RFI #91: Top Mat Rebar Spacing

Revision	0	Status	Open
To	Jeff Villacres (LERA Engineering, P.C.) (Response Required) Adi Klein (OLI Architecture, PLLC) (Response Required) Alex Dmitrashchuk (OLI Architecture, PLLC) (Response Required) Jenny Lin (OLI Architecture, PLLC) (Response Required)	From	Cameron Moncrief (Cardella Construction Co, LLC)
Date Initiated	Jan 13, 2026	Due Date	Jan 18, 2026
Location	Finished Slab	Project Stage	Course of Construction
Cost Impact	TBD	Schedule Impact	TBD
Spec Section	033000 - Cast-in-Place Concrete	Cost Code

PASSAGE OF TIME PAVILLION

S-105.2

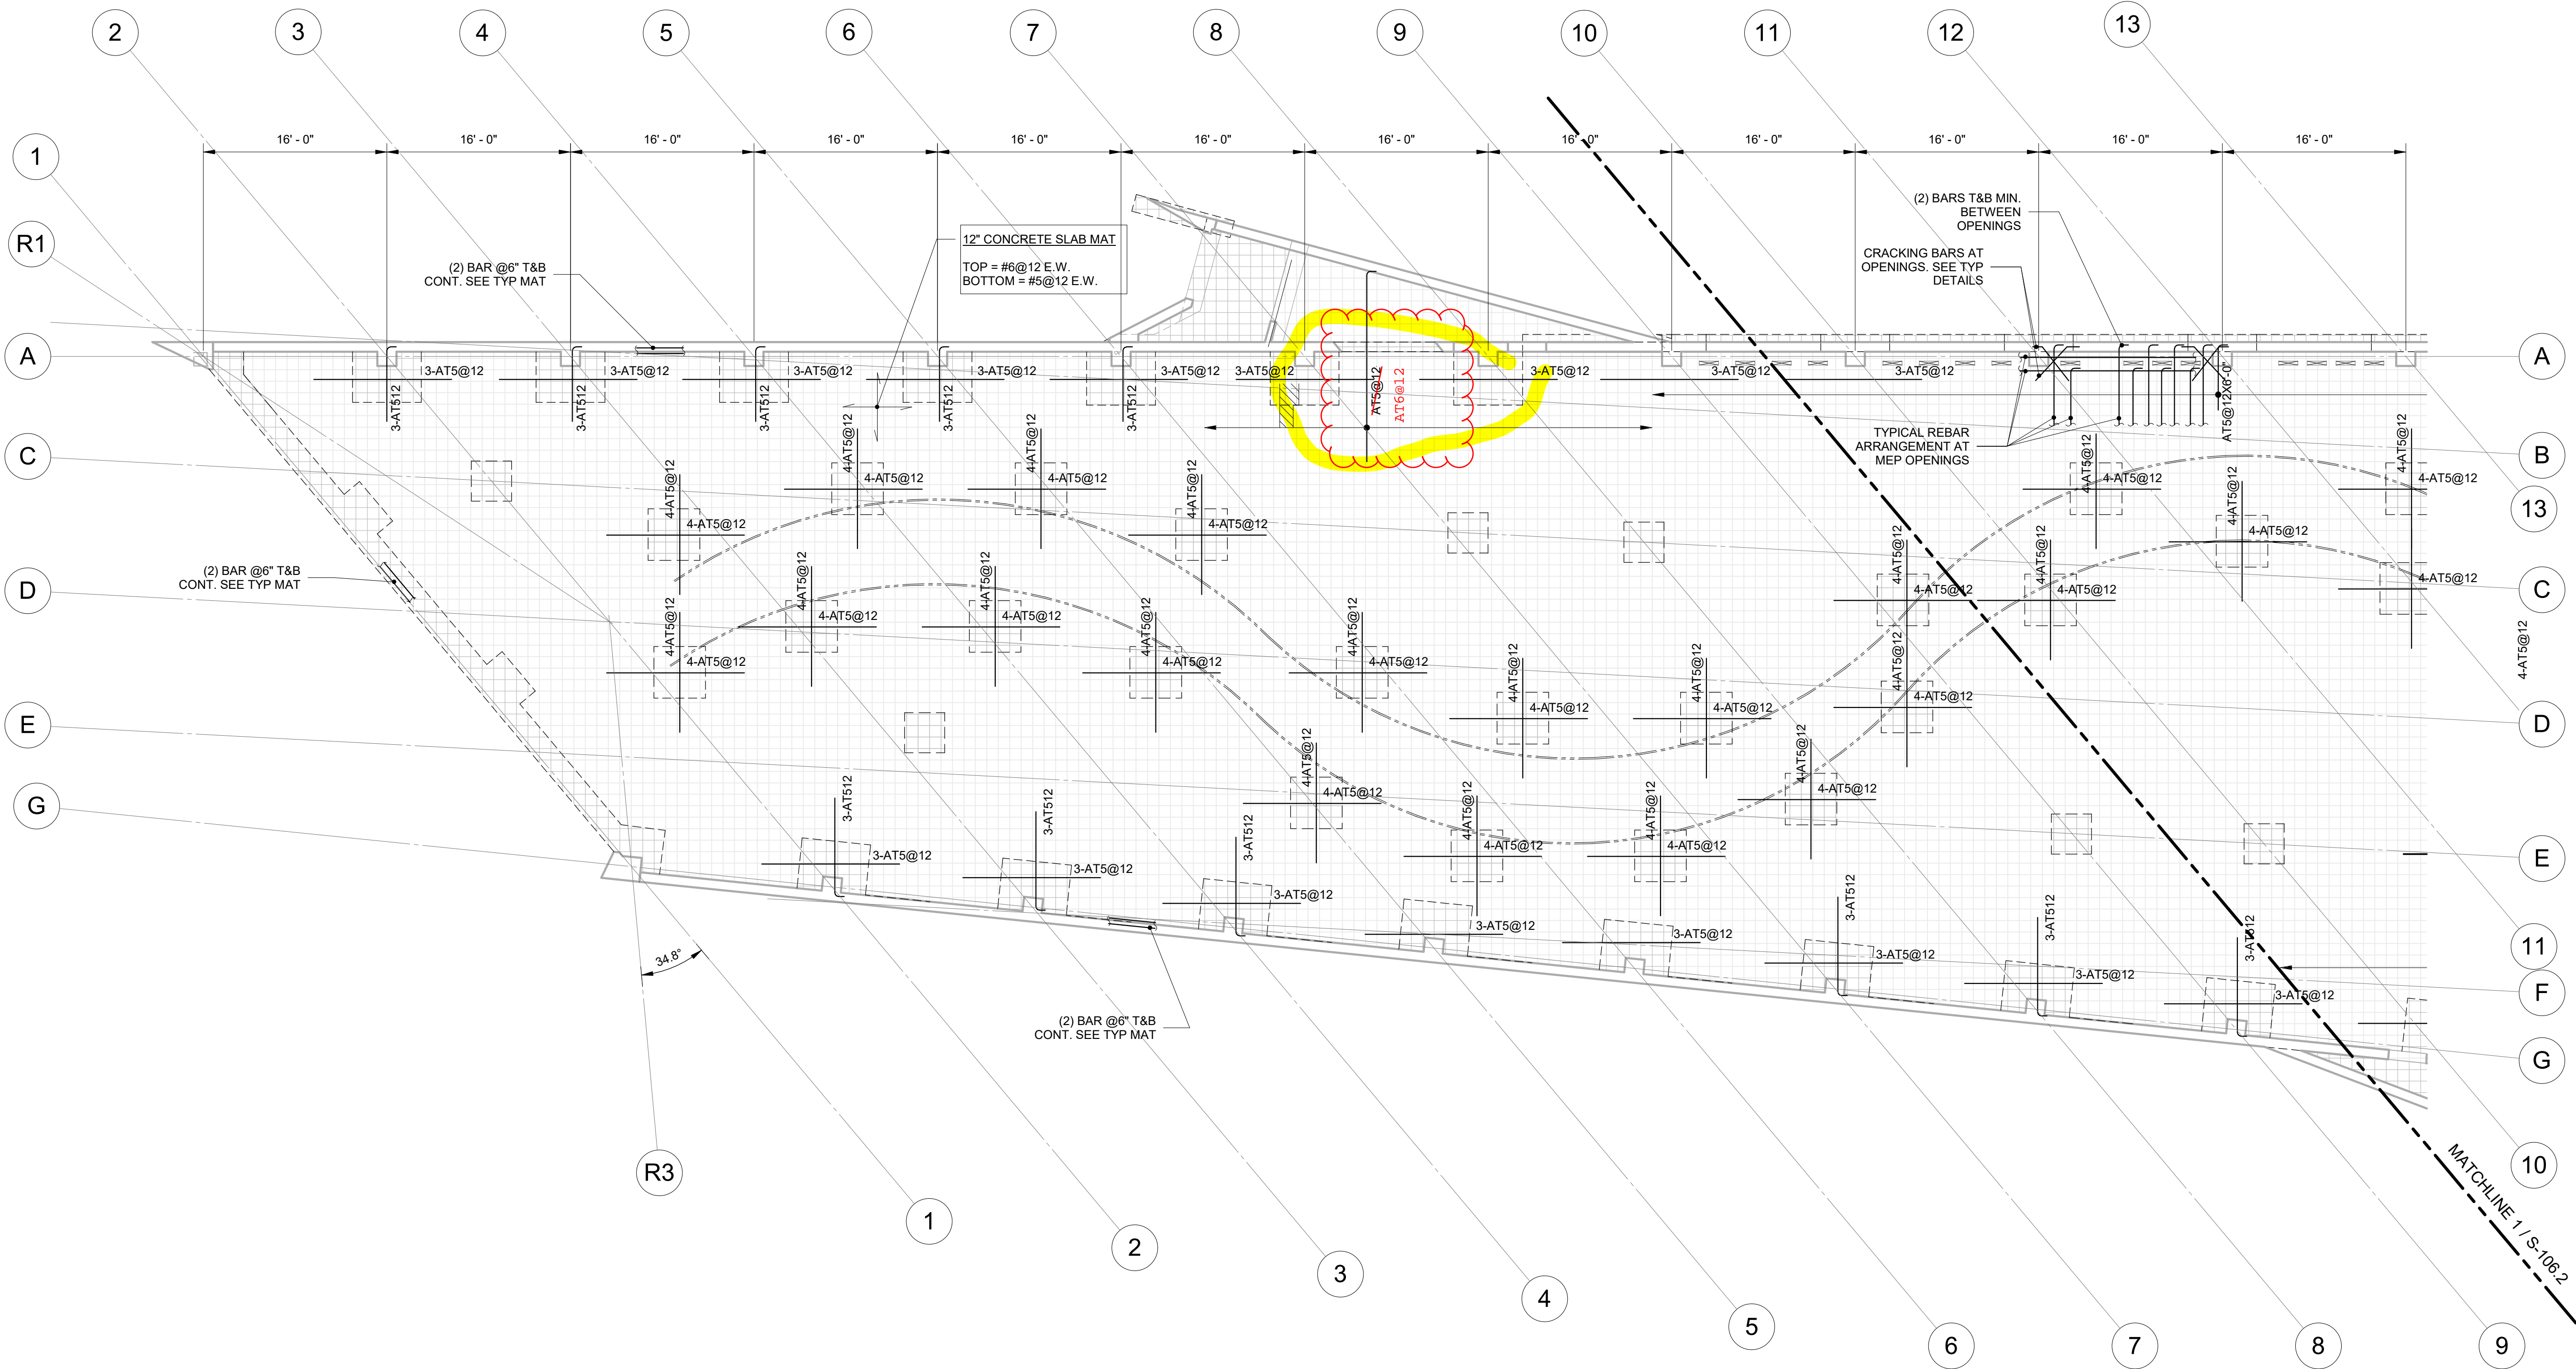
Drawing Number	S-106	<div>OLI Comments:</div> <div>- Please refer to LERA comments.</div> <div>- Increasing the top reinforcement cover to 2 inches will result in a potentially increased tendency for cracking due to greater concrete cover. The extent of additional cracking cannot be quantified. Acceptance of this condition differs from the Contract Documents and original design intent and is subject to Client approval.</div> <div>- Per Specification Section 033000-3.12, curing of concrete is required in accordance with the Contract Documents and applicable ACI standards. Given the increased clear cover, curing methodology is critical to performance. Immediate and continuous 7-day wet curing (curing mats and/or continuous misting or soaker hoses), consistent with ACI 308, is essential and can reduce early-age shrinkage, surface distress, and the severity and frequency of cracking, and must be performed. The curing procedure shall be coordinated and confirmed prior to concrete placement via a curing method statement.</div> <div>- Final approval is pending receipt of updated shop drawings clearly indicating the revised top mat cover, rebar sizes, and locations, for OLI and LERA review and approval.</div> <div>- Upon Client approval, the revised reinforcement cover and any associated rebar changes shall be explicitly incorporated into the slab mock-up for review and documentation, and a 7-day wet cure per ACI 308 must be successfully executed in the mock-up.</div>

Question	<p>Question from Cameron Moncrief Cardella Construction Co, LLC on Monday, Jan 12, 2026 at 05:01 PM EST</p> <p>Per LERA response on RFI #61, we are electing to lower the top mat of rebar to 2" cover. LERA, please confirm the following:</p> <ol style="list-style-type: none">Per RFI #61 between Grid lines 9-12.5 above the south vestibule, between grid lines 16-17 in the northeast corner, and between Grid lines 7-8 below the north vestibule show areas that the Rebar size needs to be increased from a #5 to a #6. Please confirm the exact locations that we need to change the rebar from #5 to #6 as well as any rebar spacing that needs to change. <p>Attachments Pages from 251031_RFI #61 Top Reinforcement Depth at Slab – Potential "Ghosting" Concern_LERA+OLI+RHa Response (3).pdf</p>
-----------------	--

LERA: LERA CONFIRMS THE PROVIDED SSK-14 REINFORCING MARKUPS WOULD BE NECESSARY IN ORDER TO PROVIDE 2" COVER WITHIN THE TOP REBAR MAT. GC WILL NEED TO UPDATE AND RESUBMIT SHOP DRAWINGS FOR FORMAL APPROVAL
